Land at Bird in Eye Farm
South of Bird in Eye Hill
Uckfield

TRANSPORT ASSESSMENT ADDENDUM

ITR/MT/5330/TAA.4
March 2022

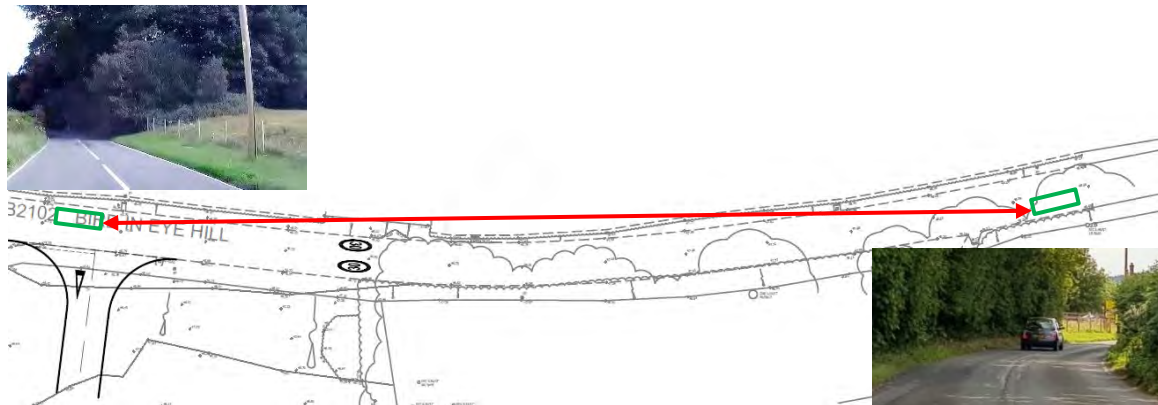
Location: Bird in Eye Hill

Summary: Drivers approaching and waiting to turn right into the proposed access may not become aware of each other at a safe distance

The B2102 Bird in Eye Hill is a two-way single carriageway road that is derestricted and therefore subject to the 60mph but according to data contained within the Audit Brief, observes 85th percentile eastbound speeds of 39.9mph and westbound speeds of 43.4mph. The proposals that are subject to this Stage 1 Road Safety Audit includes the provision of a simple priority access off the southern side of the carriageway just to the west of a bend in the road. The scheme drawing provided with the Audit Brief illustrates that a visibility splay of 2.4x125.2 metres is achievable to the right (west) of the proposed access to leading traffic, which accords with the stopping sight distance of the 85th percentile approach speed recorded. However, due to the bend in the road and vegetation within the verge to the north, forward visibility to and from a vehicle attempting to turn right into the access, is limited. As such, right turning vehicle may undertake their manoeuvre across the path of an oncoming vehicle leading to a side impact collision.

As stated by the Auditor's, the proposed access is clearly visible for westbound drivers and the introduction of the 30mph speed limit and traffic calming features will change the characteristic of this section of Bird in Eye Hill and reduce traffic speeds. One would therefore approach cautiously in the knowledge that a vehicle may attempt to turn right. The 90-95m forward visibility envelope that is achievable across the carriageway in this direction, is considered sufficient.

CLIENT			Croudace Homes Ltd.		
PROJECT			Bird in Eye, Uckfield		
TITLE			Proposed Improvements Framfield Road Sheet 1 of 2		
DRAWN BY		DESIGN BY		CHK BY	
AM/JCB		MT		MT	
DATE		DRAWING No.		REV No.	
06/04/21		5330 / 017		E	
SCALE					
1:500 @ A1

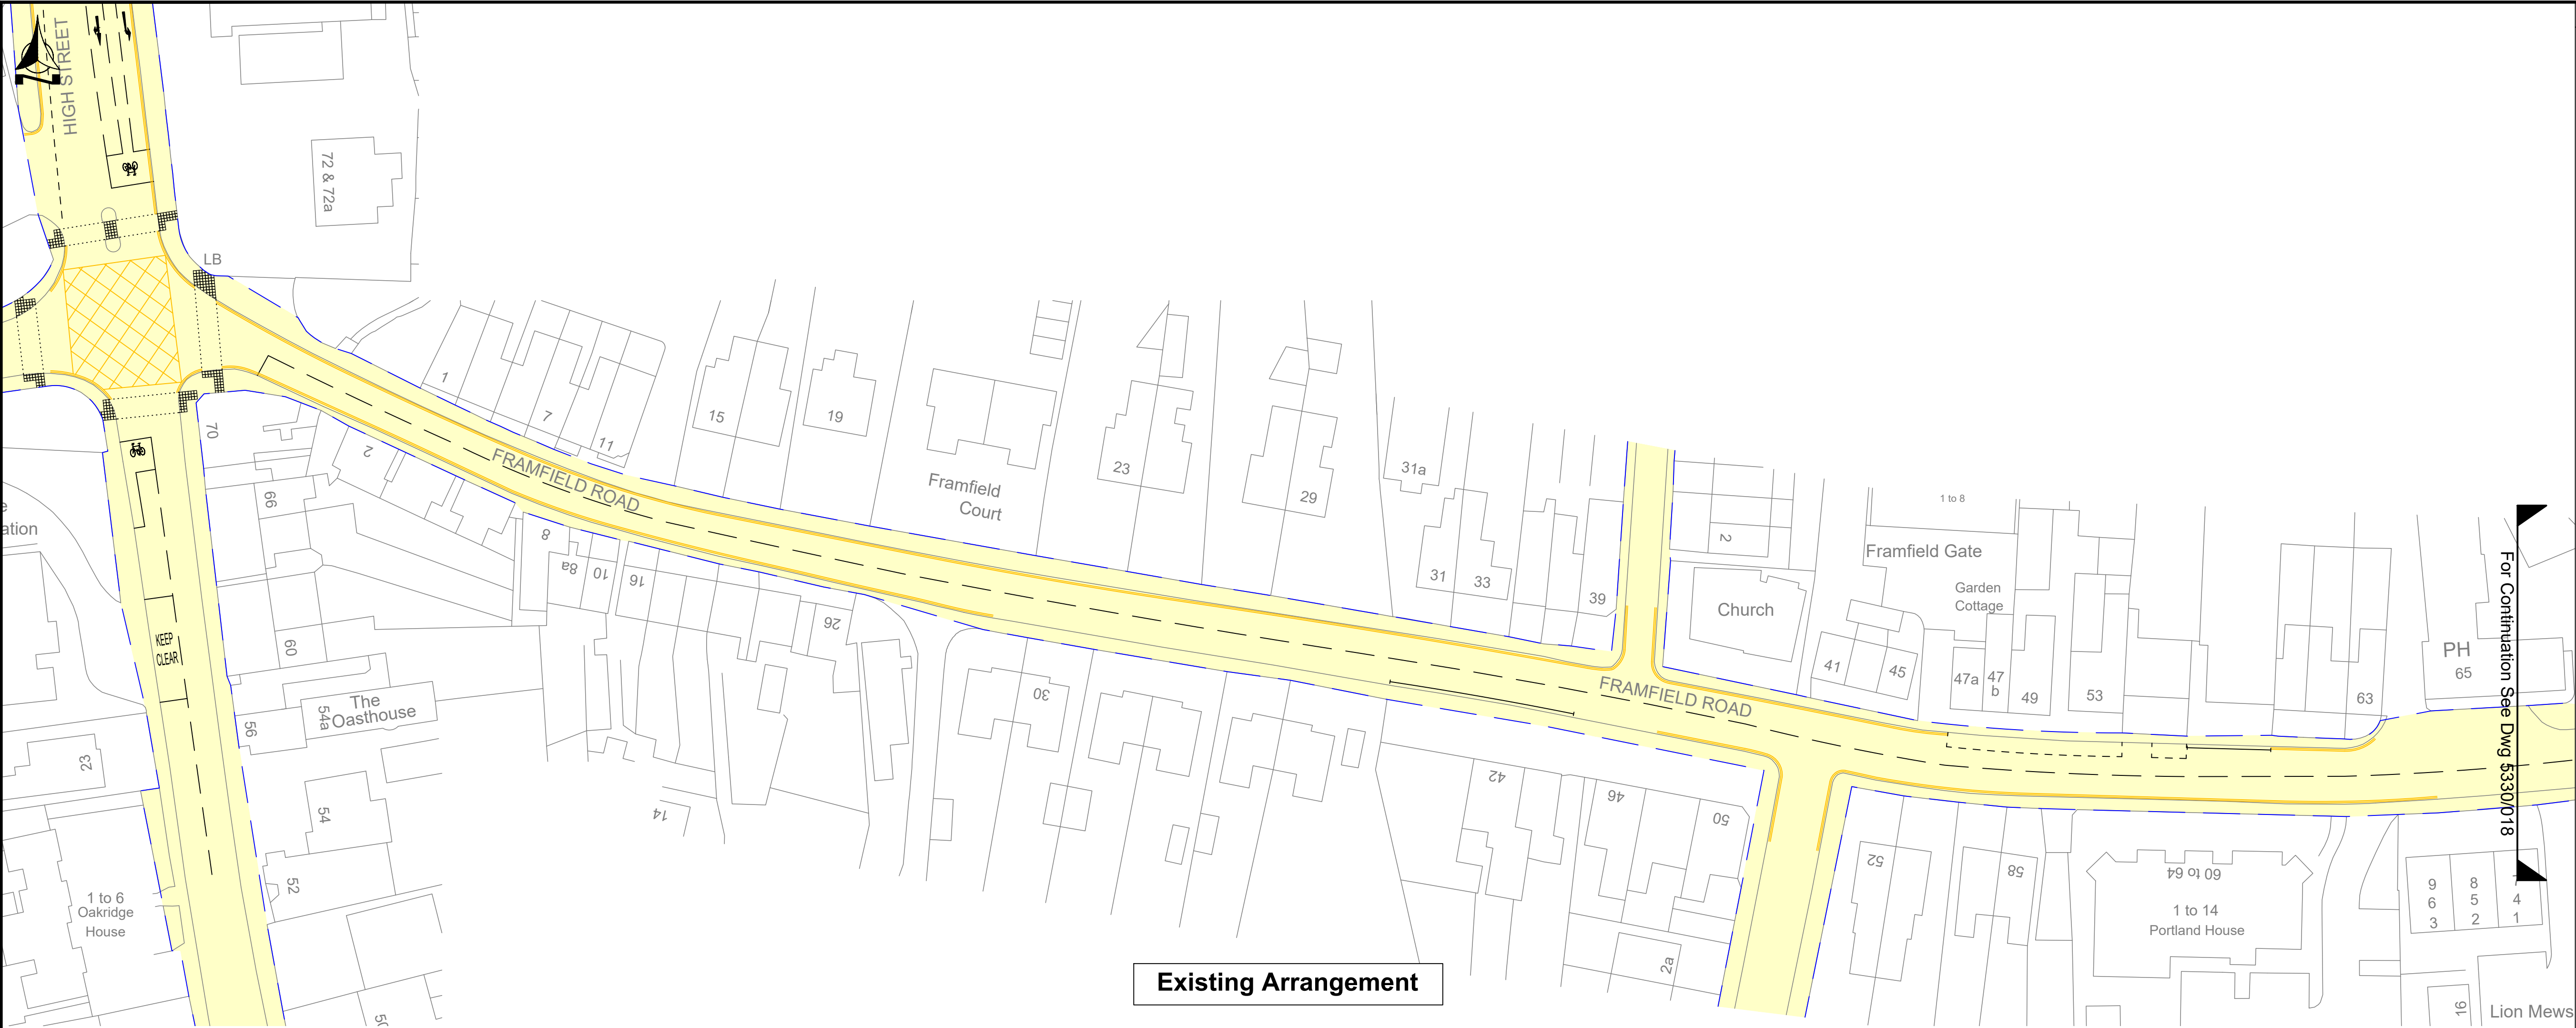
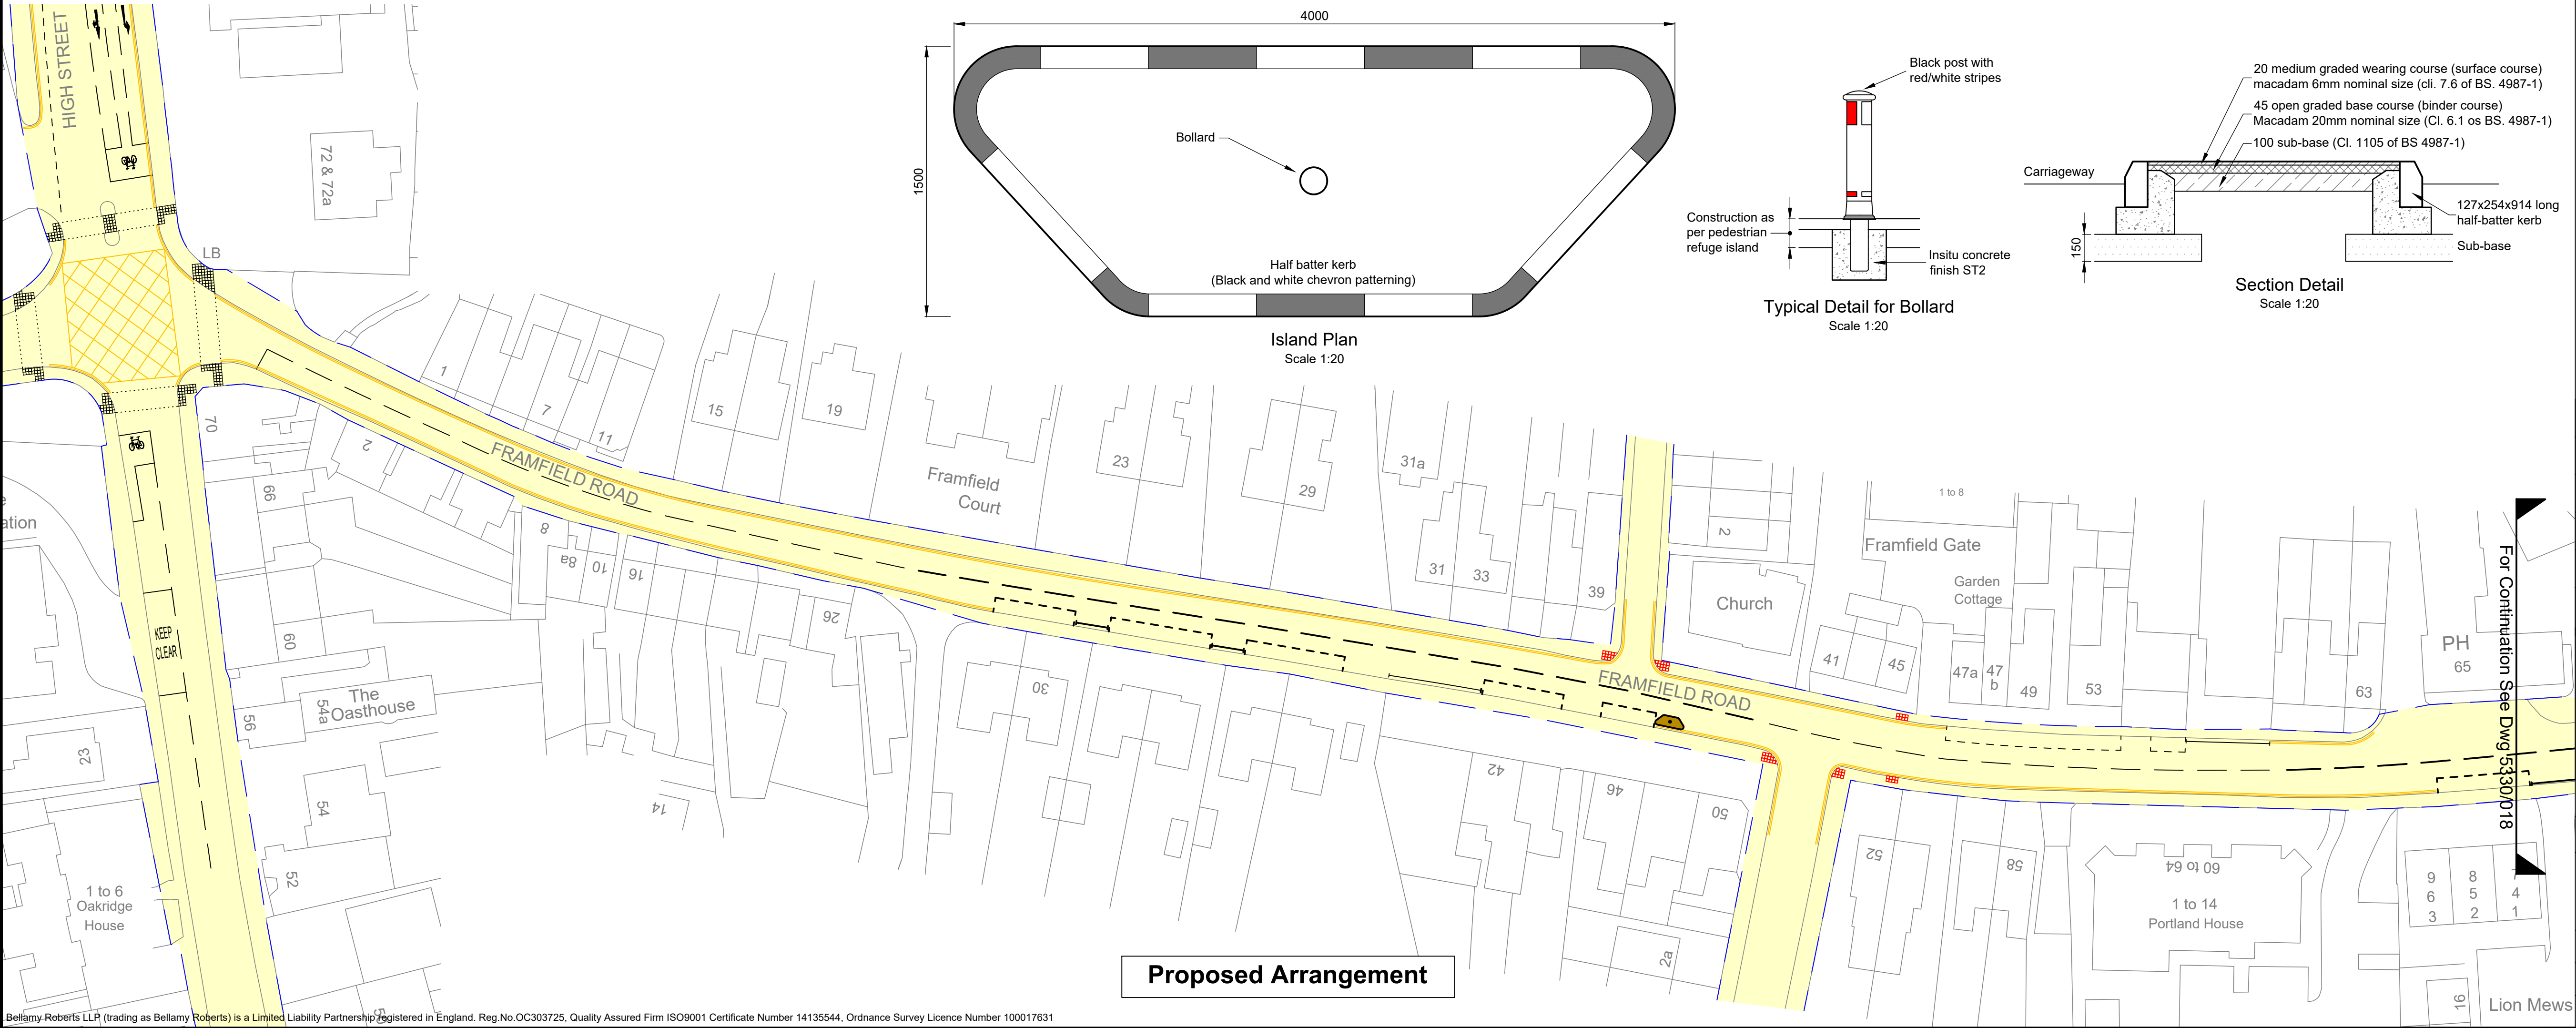
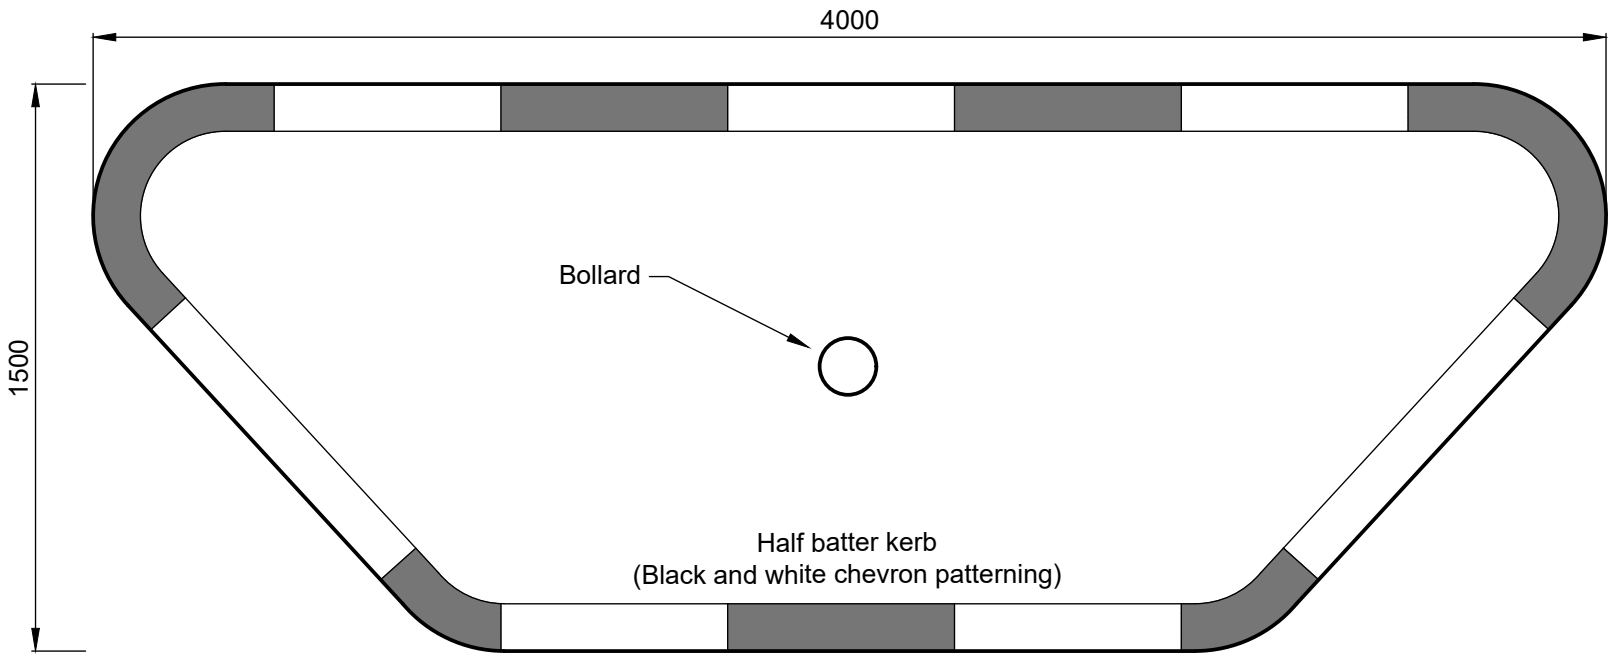
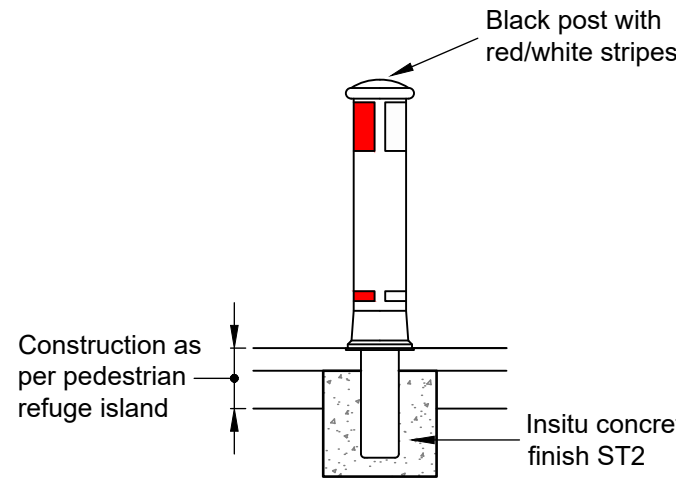
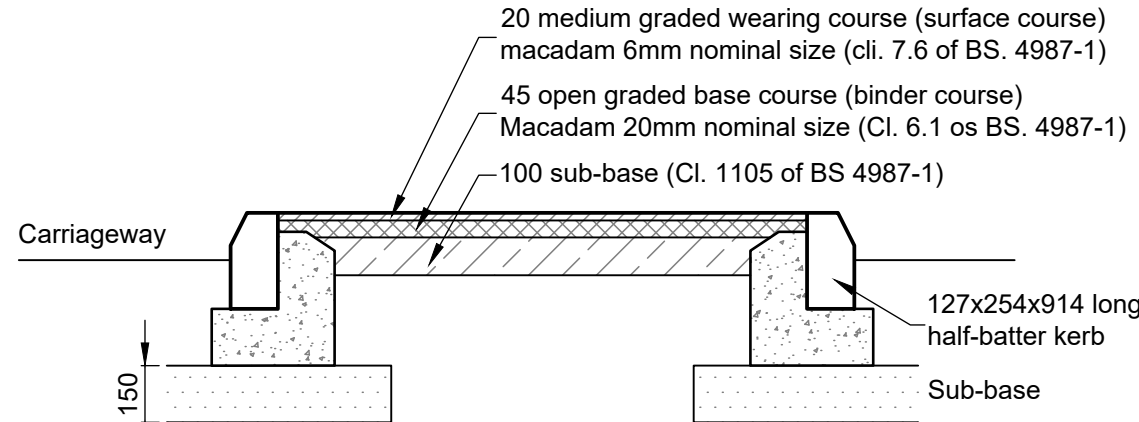
2.28 The Highway Authority suggested during the meeting of 12th January that the crossing point proposed in the vicinity of 2-8 Framfield Road should be relocated to the vicinity of Alexandra Road. The crossing point has been relocated as requested (see drawing 5330/017 rev. E & 5330/018 rev. D at **Appendix 9**).

2.29 The Highway Authority has requested this proposed crossing point and bus stop improvements be included within the scope of the Road Safety Audit. The relevant drawings have been submitted to the Auditor and revised accordingly following receipt of their comments.
